FINAL PRODUCT/PROCESS CHANGE NOTIFICATION #20183

TITLE: Wafer Fabrication Site Transfer (Transistor in STK4XX Product)

AFFECTED CHANGE CATEGORY(S): Wafer Fab Site Change

Equivalent Block Diagram (example: STK433-130N-E)

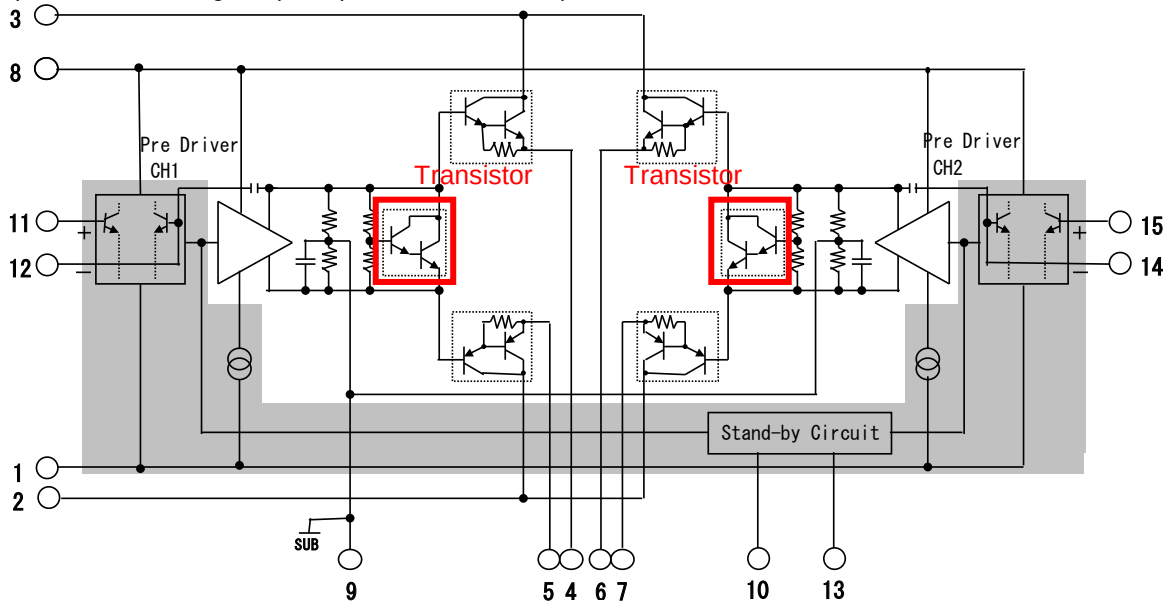
The IGBT components labeled as **TRANSISTOR** in red below are being discontinued due to the Fab closure of Sanyo Gunma Fab. The replacement IGBT component now qualified will be sourced from ON Semiconductor ISMF Fab located in Seremban, Malaysia. ISMF is an internal ON Semiconductor Fab with a long history of production. It is ISO/TS16949 certified. < http://www.onsemi.com/PowerSolutions/content.do?id=1138>

Change parts

About parts of red wire, wafer fab site changed.
